APPARATUS AFFECTED: DATASPEED 40AB101/AA Answer-Back.

PART AFFECTED: TP410722 Answer-Back Circuit Card  
Assembly (MC722).  
TP305821 Capacitor

NEW-STYLE TP410722 CIRCUIT CARD ASSEMBLY  
(CUSTOMER IDENTIFICATION ISSUE 8A)

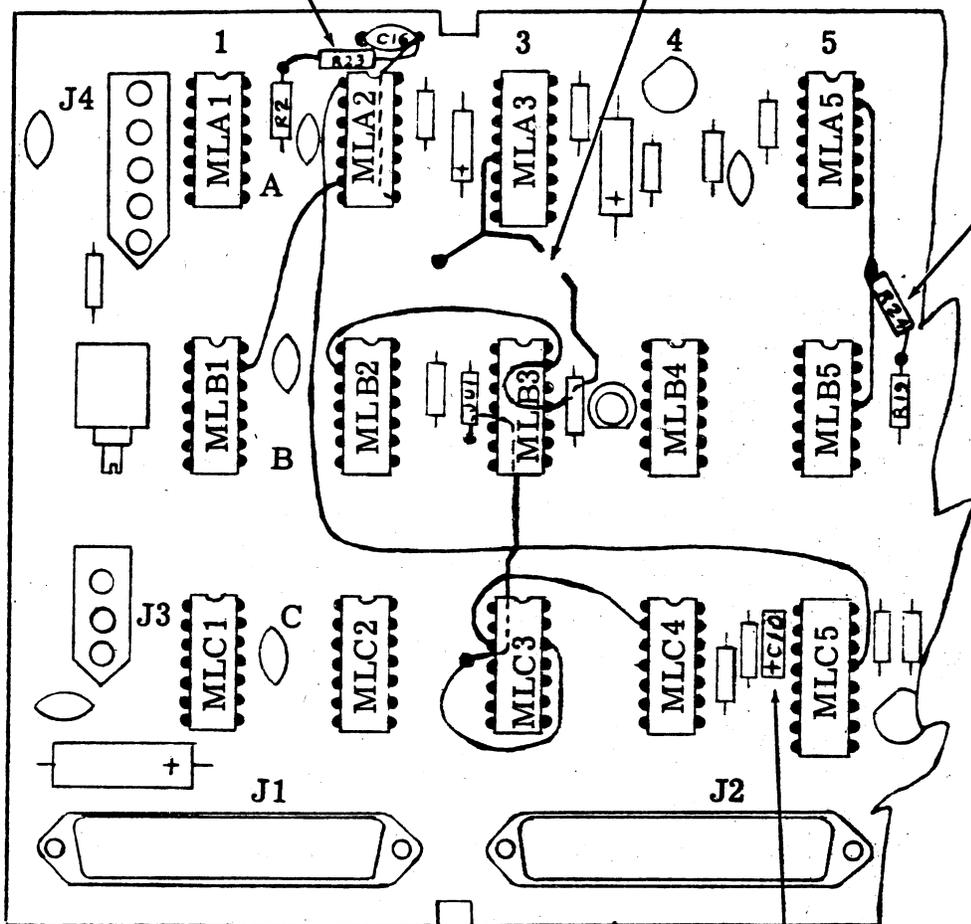
R23 (TP315971 - 680 OHM) ADDED FROM LAND FOR UPPER LEAD OF R2 TO LAND FOR RIGHT LEAD OF C16. LEADS OF R23 COVERED WITH SLEEVING.

ETCHING TO MLB3-11 CUT.

R24 (TP321213 - 1K OHM) ADDED (FROM LAND FOR UPPER LEAD OF R19 TO PLATED THRU HOLE).

ETCHING TO MLC3-9 CUT.

C10 CAPACITOR (0.1 MFD) REPLACED BY TP336948 (1.0 MFD). POSITIVE (+) END OF TP336948 TO LOWER LAND.

INSULATED STRAPS ADDED  
(See above)

FROM MLB3-11 TO MLB3-13.  
FROM MLC3-12 TO PLATED THRU HOLE (TO JU1 STRAP).
